MANDATORY SERVICE BULLETIN

MSB 42-149

MSB 42NG-095

Actions to prevent Passenger Door Separation: Installation of Placards, AFM Procedure update and Inspection/Data Gathering.

Data collection: Identify the version of the Safety Hook.

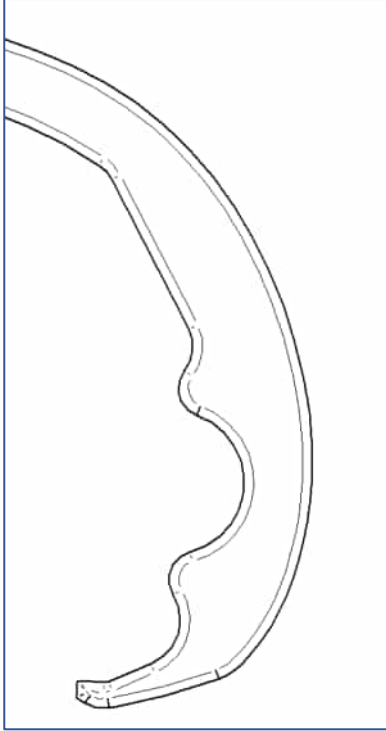
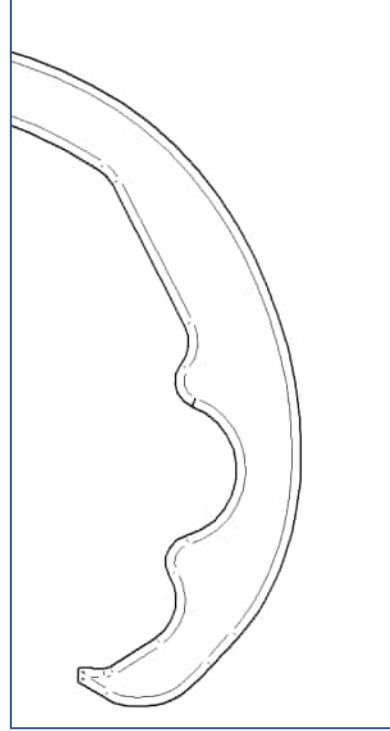
- Record the version of the Safety Hook on the execution report in Appendix B.

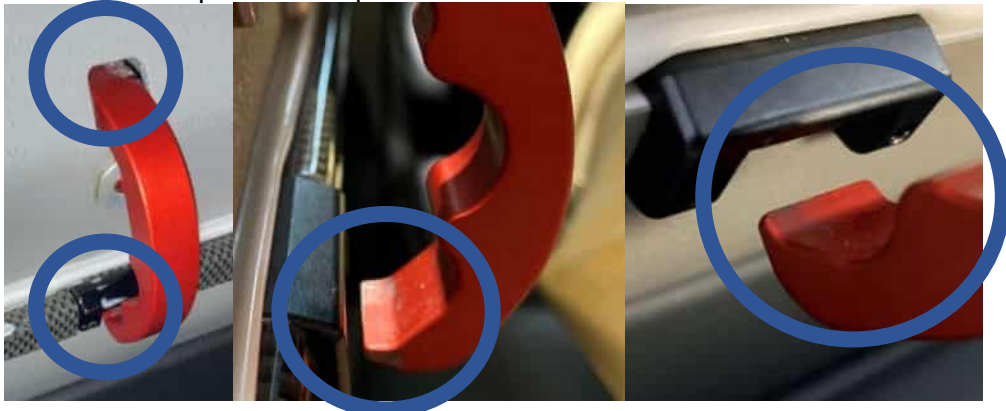
- 6 Examine the Safety Hook for signs of wear, corrosion and poor condition:
- Record the finding on the execution report in Appendix B.
 - There must be no deformation or cracks.
 - Pay particular attention to the contact area of the Actuation Pin.
 - Grooves in the Safety Hook must be less than 2 mm deep.

- Pay particular attention to the hook end of the Safety Hook.
 - The hook end must not be bent.
 - Not acceptable:

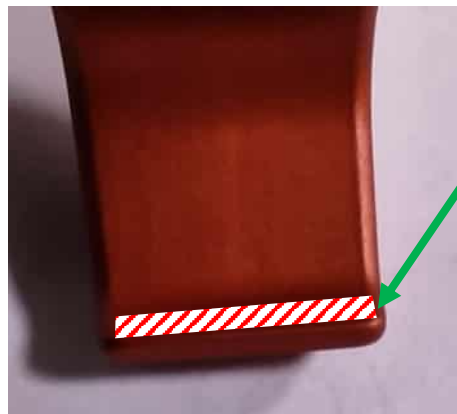
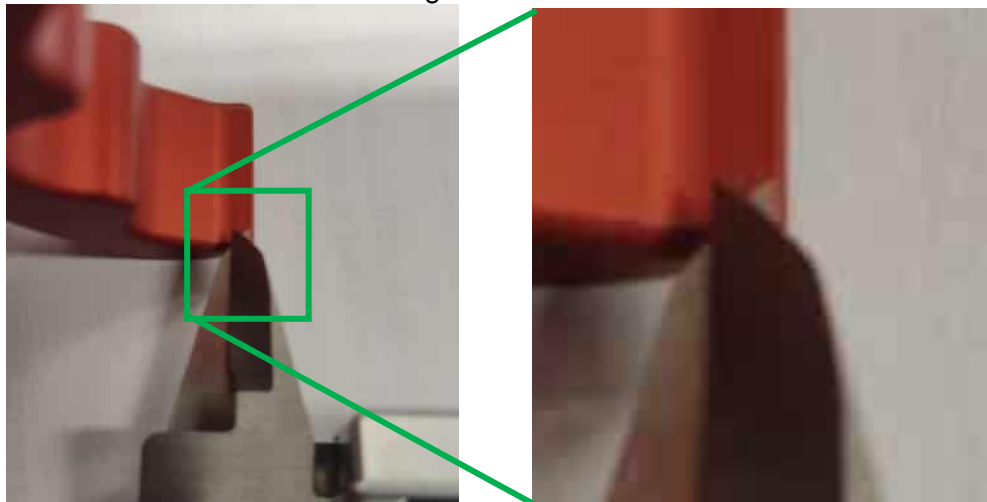
- Examine the tip of the Safety Hook for wear:
 - Wear of edges of Safety Hook:
 - The width of the tip of the Safety Hook must be greater than 10.5 mm.

- The engaging surface of the Safety Hook is the flat surface at the tip of the Safety Hook.
 - It must be free from steps and ridges.
 - Scratches or uniform wear of surface protection are permitted.

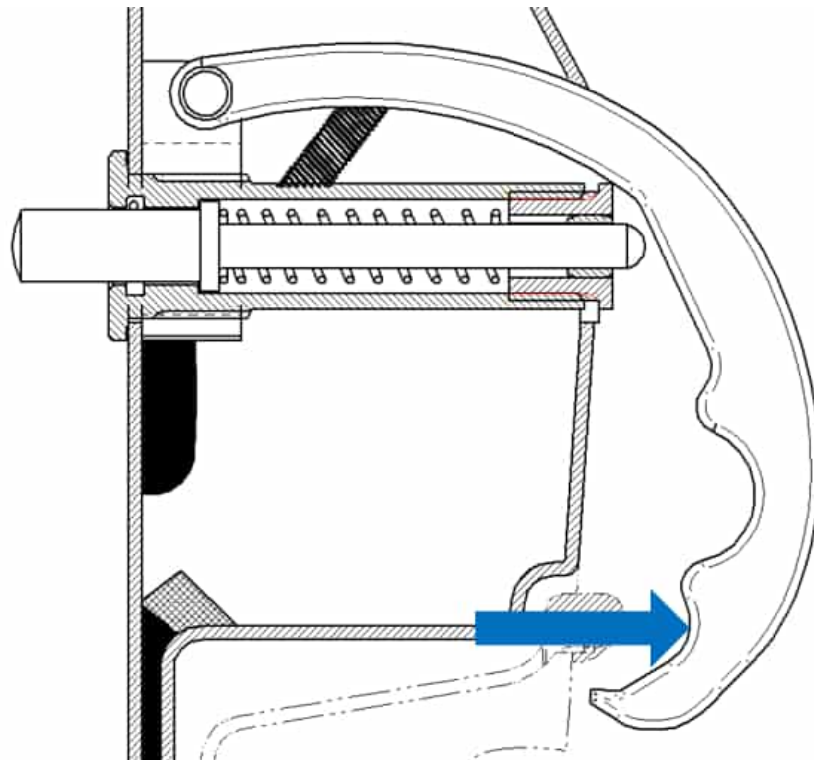
- Measure the width of the engaging surface.
 - The width must be greater than 1.5 mm.

- Measure the maximum thickness of the Safety Hook at the location of the engaging surface, perpendicular to the engaging surface.
 - The thickness must be greater than 2.5 mm.
 - The maximum variation of measured thickness over the width of the Safety Hook must be less than 0.2 mm.

- Measure the minimum thickness of the Safety Hook at the location of the engaging surface, perpendicular to the engaging surface.
 - The minimum thickness must be greater than 1.5 mm.
 - The maximum variation of this value over the whole width must be less than 0.2 mm.

- The edge of the engaging section of the Safety Hook that is facing towards the Retaining Bracket must be free from ridges.

Replace Safety Hook, if

- any of the Safety Hook dimensions measured in this step are not within the given tolerances, or
- corrosion is found, or
- deformation, grooves, ridges or steps.

8 Data Collection: Identify the version of the Retaining Bracket:

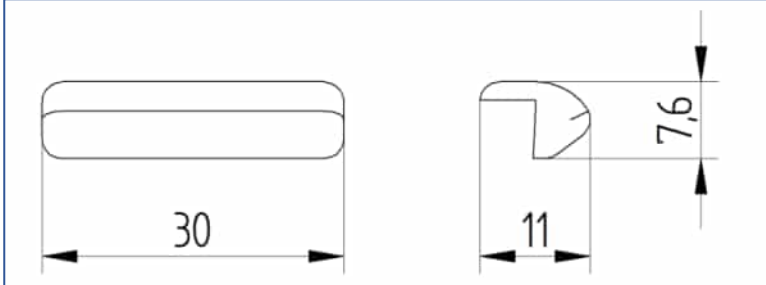
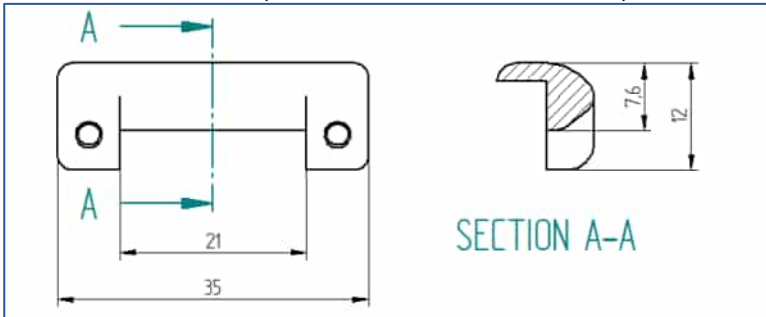
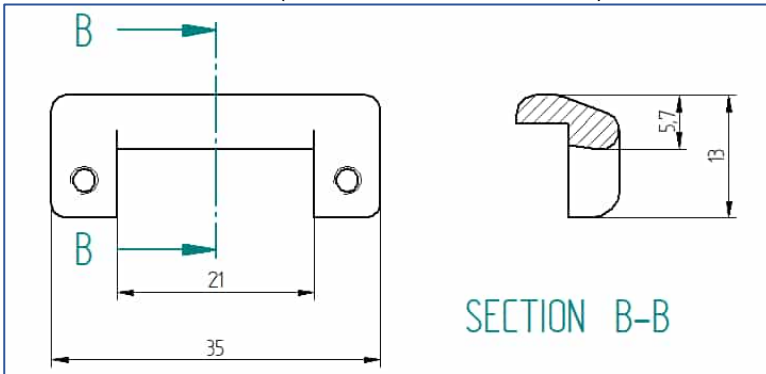
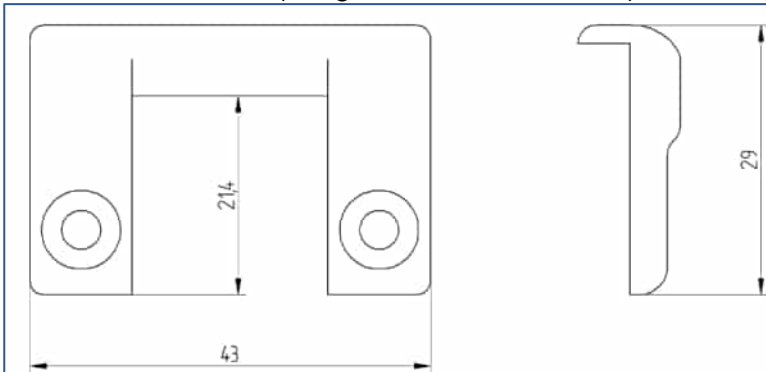
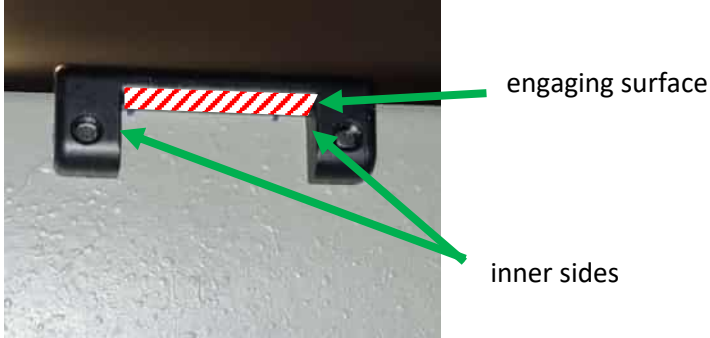
Record the version of the Retaining Bracket on the execution report in Appendix B.

9	<p>If Retaining Bracket DA4-5200-00-69 is installed (refer to step 8.):</p> <ul style="list-style-type: none"> • Replace the Retaining Bracket according to MSB 42-083/MSB 42NG-014 (refer also to EASA AD 2010-0235). • Record replacement of the retaining bracket on the execution report in Appendix B.
10	<p>Examine the Retaining Bracket for signs of wear, corrosion and poor condition.</p> <ul style="list-style-type: none"> • There must be no corrosion on the Retaining Bracket. • Wear at the inner sides of the Retaining Bracket: maximum 0.5 mm per side. • The engaging surface of the Retaining Bracket and the edge of the engaging surface facing the Retaining Bracket must be free from steps and ridges. • Scratches or uniform wear of surface protection are permitted.  <ul style="list-style-type: none"> • The thickness of the Retaining Bracket measured perpendicular to the upper surface must be greater than <ul style="list-style-type: none"> ○ 4 mm (for Retaining Bracket DA4-5200-00-69_02 (extended with undercut), or ○ 6 mm (for all other Retaining Brackets, refer to Step 8).  <ul style="list-style-type: none"> • The width of the Retaining Bracket (measured i.a.w. picture below) must be greater than 10 mm. <ul style="list-style-type: none"> ○ Variation of the width over the whole length of the Retaining Bracket must be less than 0.2 mm.

11 Examine if the Safety Hook properly engages in the Retaining Bracket:

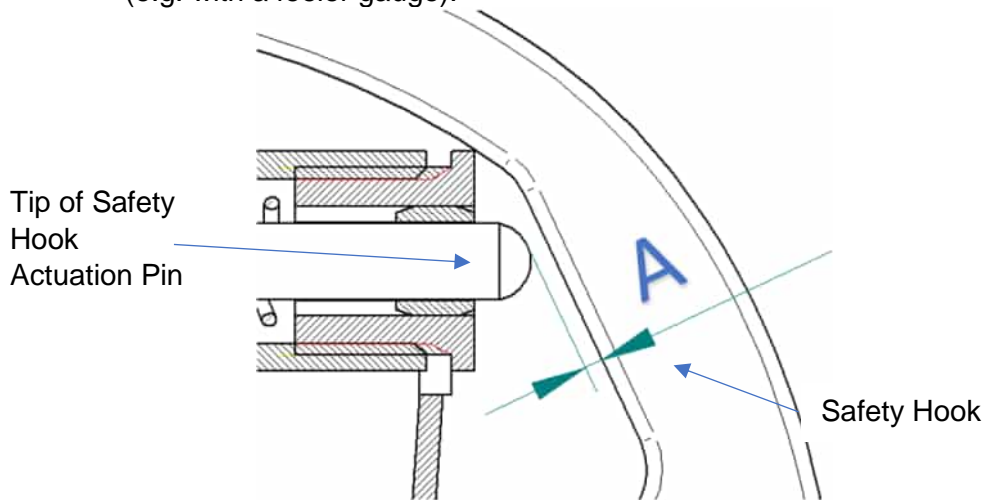
The Safety Hook Actuation Pin must not be pressed during this step.

- Close and latch the Passenger Door.
- Unlatch the Passenger Door from the outside and pull on the outer Passenger Door Handle.
 - The Safety Hook must engage in the Retaining Bracket and prevent the Passenger Door from further opening.
- Pull on the outer Passenger Door Handle with 15 ± 1 kg / 150 ± 10 N.
 - The Safety Hook must not disengage but must remain properly engaged in the Retaining Bracket
- Record the check results on the execution report in Appendix B.

If the Safety Hook disengages, identify the cause, record it on the execution report in Appendix B **and** contact Diamond Aircraft Industries GmbH.

12 Data Collection: Measure the following dimensions:

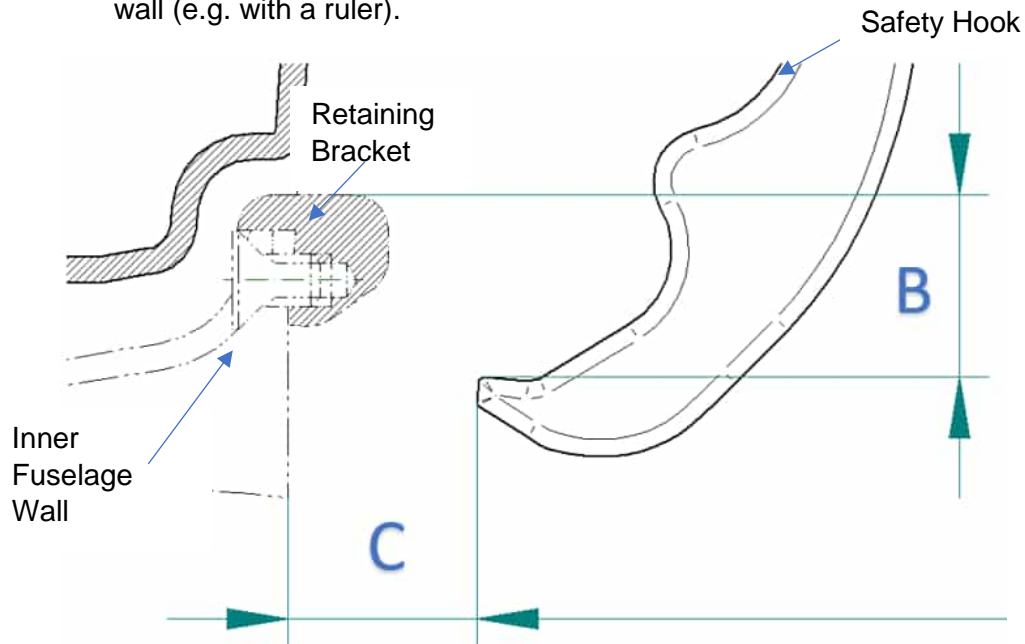
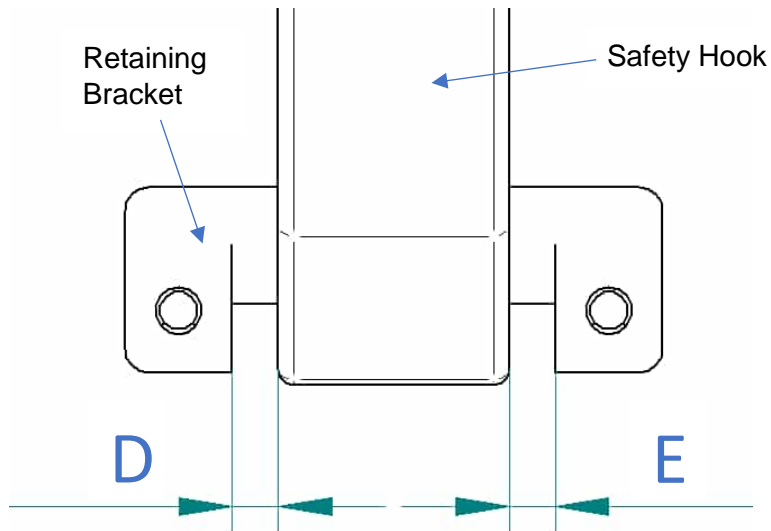
- Close and latch the Passenger Door.
- Record the measurements on the execution report in Appendix B.
 - Dimension A: distance of Actuation Pin to Safety Hook in resting position (e.g. with a feeler gauge).

- Dimension B: distance between top surface of the Retaining Bracket to top surface of engaging section of Safety Hook in resting position of Safety Hook (e.g. with a ruler).
- Dimension C: horizontal distance between tip of Safety Hook and fuselage wall (e.g. with a ruler).

- Unlatch the Passenger Door and push the Passenger Door open, engaging the Safety Hook into the Retaining Bracket, apply slight pressure to the Passenger Door to keep the Safety Hook engaged during the measurement.
- Record the measurements on the execution report in Appendix B.
 - Dimension D (e.g. with a ruler).
 - Dimension E (e.g. with a ruler).

19 If MÄM 42-097 is installed (refer to step 15), examine the adjustment of the gas spring in the Passenger Door latching mechanism.

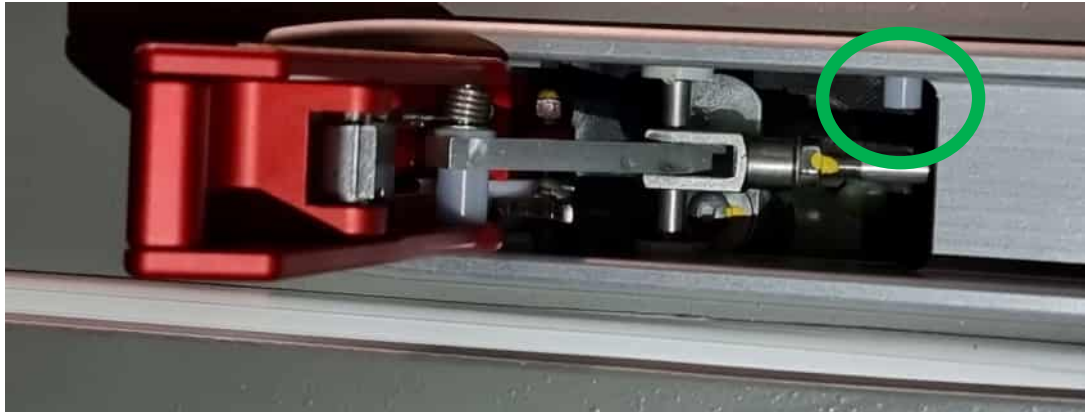
The gas spring inside the door handle must push the door handle into the latched position firmly against the stop:

- Open the Passenger Door.
- Move the Passenger Door Handle to the latched position.
- Examine, if the door handle is pushed into the mechanical stop inside the door handle mechanism (marked in the pictures below).
- If the Passenger Door Handle is not pushed against the mechanical stop by the gas spring, adjust the gas spring (refer to AMM section 52-10) and repeat this step.
- Record whether the gas spring was adjusted properly on the execution report in Appendix B.

20 Data collection: Position of the outside Passenger Door Handle.

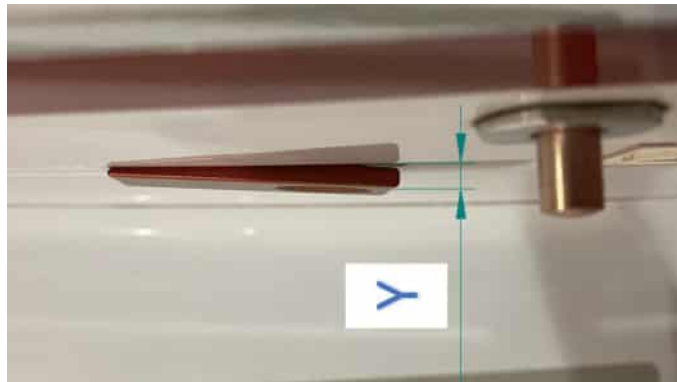
- Close the Passenger Door.
- Press the outside Passenger Door handle into the latched position until a distinct stop is reached.
- Examine if the Passenger Door Handle is recessed, flush or protruding over the Passenger Door surface. Record the condition on the execution report in Appendix B.
- If the handle protrudes from the surface of the Passenger Door, measure the protrusion.
- Record the measurement on the execution report in Appendix B.

23 Measure the extension length of the latching bolts of the Passenger Door.

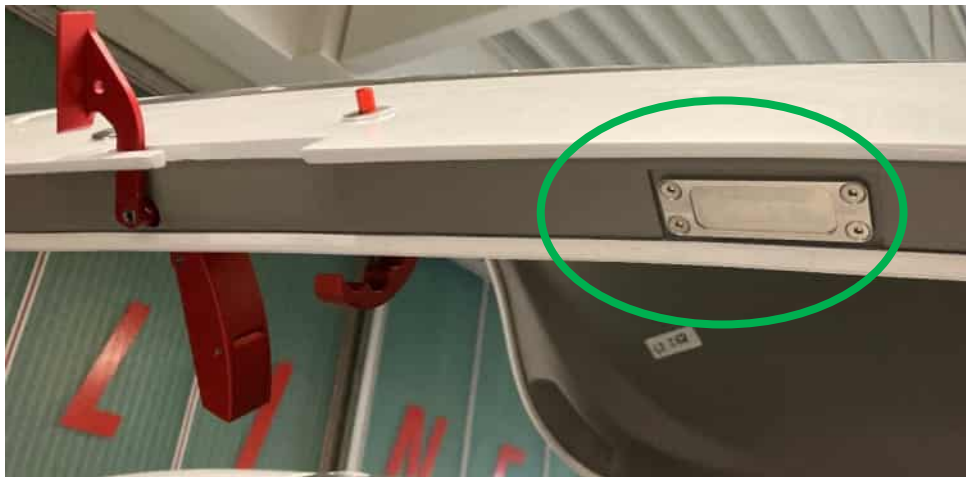
- Measure the extension length at the bottom of the front and rear latching bolts in mm. Refer to pictures below.
 - The front latching bolt extension length must be 40 ± 2 mm.

- If MÄM 42-687 is **not** installed, the rear latching bolt extension length must be 40 ± 2 mm.
 - If the extension length is out of tolerance, adjust the latching bolt if possible, or replace latching bolt if necessary.

- After adjustment or replacement repeat this step.
 - If MÄM 42-687 is installed, the rear latching bolt extension length must be 44 ± 1 mm.
 - If the extension length is out of tolerance, adjust the latching bolt if possible, or replace latching bolt if necessary.

- If the extension length is out of tolerance, adjust the latching bolt if possible, or replace latching bolt if necessary.
 - After adjustment or replacement repeat this step.

- 28 If MÄM 42-097 is installed (new latching mechanism, refer to step 15), install placard D60-1133-10-09 to the upper side of the inner canopy handle.

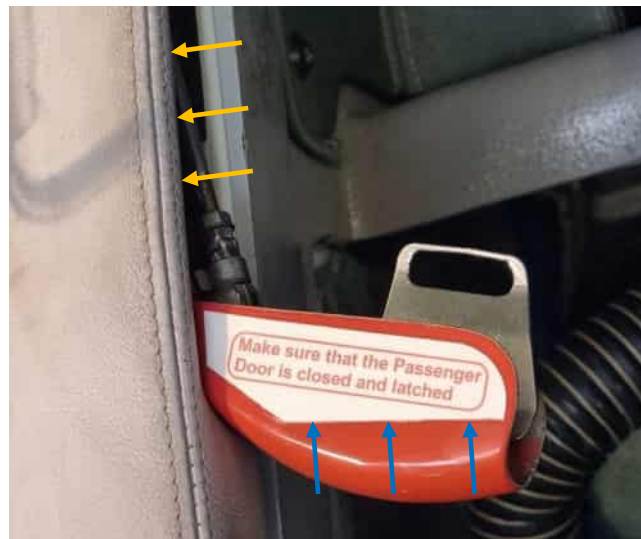
- Unlatch the canopy.
- Clean the canopy handle from dirt and grease.
- Align the placard with the straight edge and position it in spanwise direction so that it is completely visible from the pilot's perspective if the canopy handle is in the unlatched position.
- The placard must disappear when the canopy handle is in the latched position.
